Subject: MIL ILLUMINATION WITH DTC P2135	Bulletin No: 01-016/06
	Last Issued: 05/18/2006

2003 - 2005 Mazda6 3.0L

THROTTLE BODY

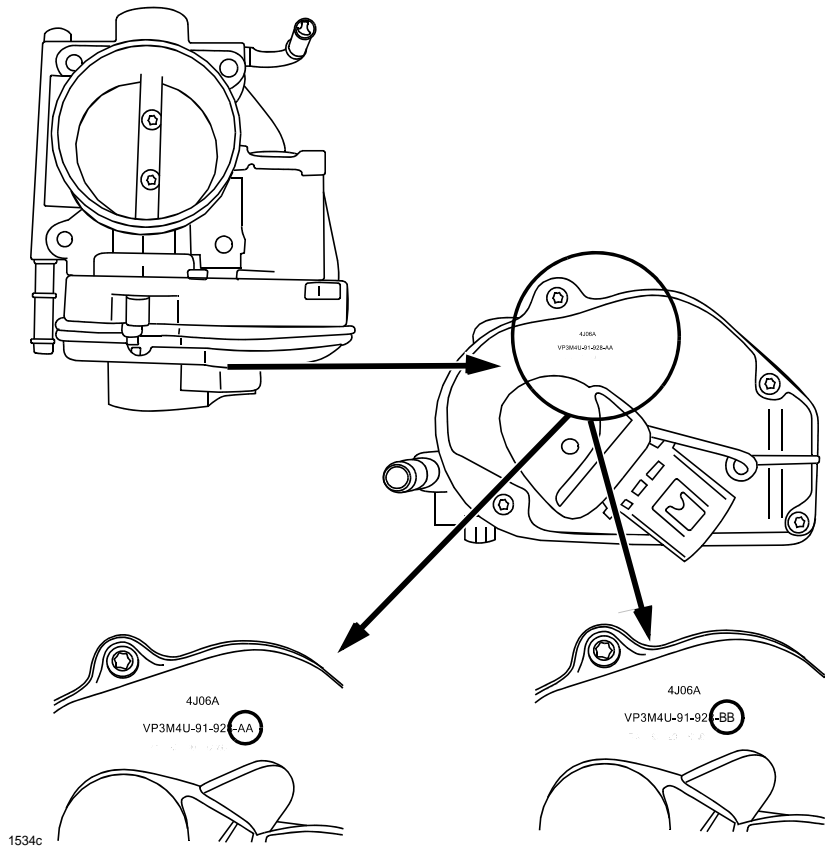
3. Inspect letters on throttle body as shown below.

AA, AB, BA MARKINGS = NO GOOD BB MARKING = GOOD

- If letters "AA", "AB", or "BA" are found on the throttle body, proceed to Step 4.
 - If letters "BB" is found on the throttle body, troubleshoot DTC according to the Workshop Manual.
4. Record customer's preset radio stations.
 5. Disconnect negative battery cable.
 6. Replace throttle body according to Workshop Manual (section 01-13 INTAKE AIR SYSTEM REMOVAL/ INSTALLATION [AJ]).
 7. Reconnect negative battery cable.
 8. Erase DTC.
 9. Re-enter customer's preset radio stations.
 10. Verify repair.
